T.I. no.: 2016 - 03 Updated: -	Topic: New SSR position
---	--------------------------------

Date: 16/02/2016
Affected machines: SCP
From serial number: 1549...
As of date: CW 49/2015

SSR position as of CW 49/2015

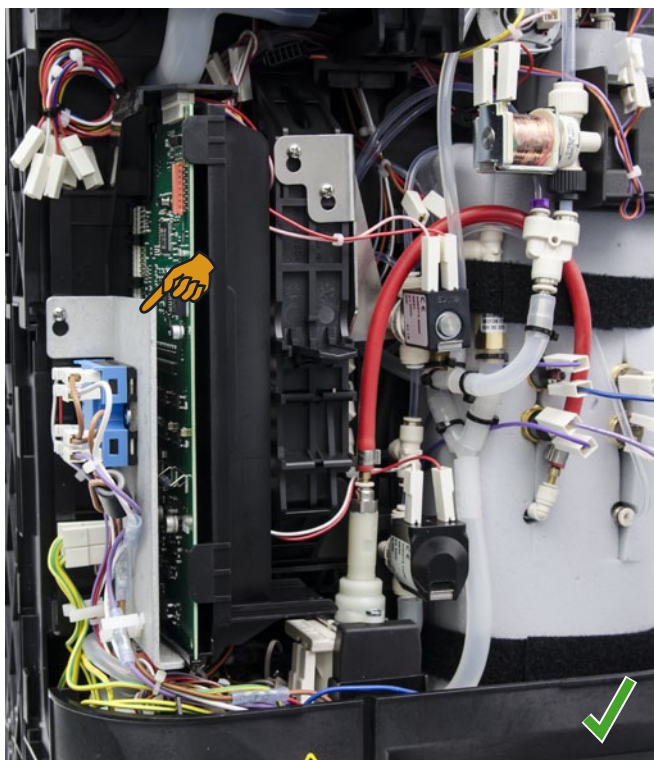
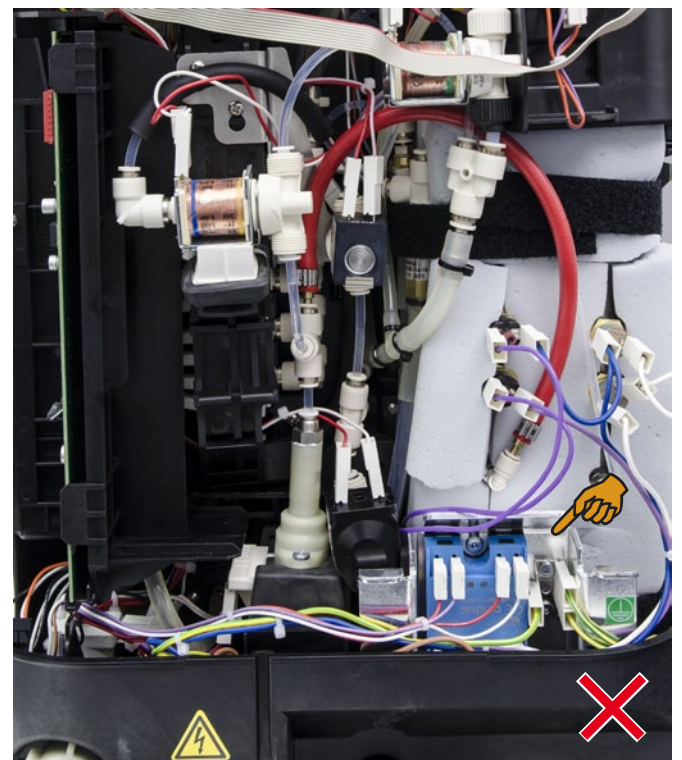
The position of the SSR in the machine was changed in CW 49/2015. The SSR is now on the left next to the power board and is screwed onto a holder on the housing. Access to the boilers and water protection have been improved with the new position.

SSR position up to CW 48/2015

The "SSR relay cpl." assembly with article number 072516 for the SCP up to production date 48/2015 (1548...) no longer exists and can no longer be ordered. If an SSR is defective, a new one can be ordered separately.

The new article number of the "SSR relay cpl." assembly for the SCP from production date 49/2015 (1549...) is 074535.
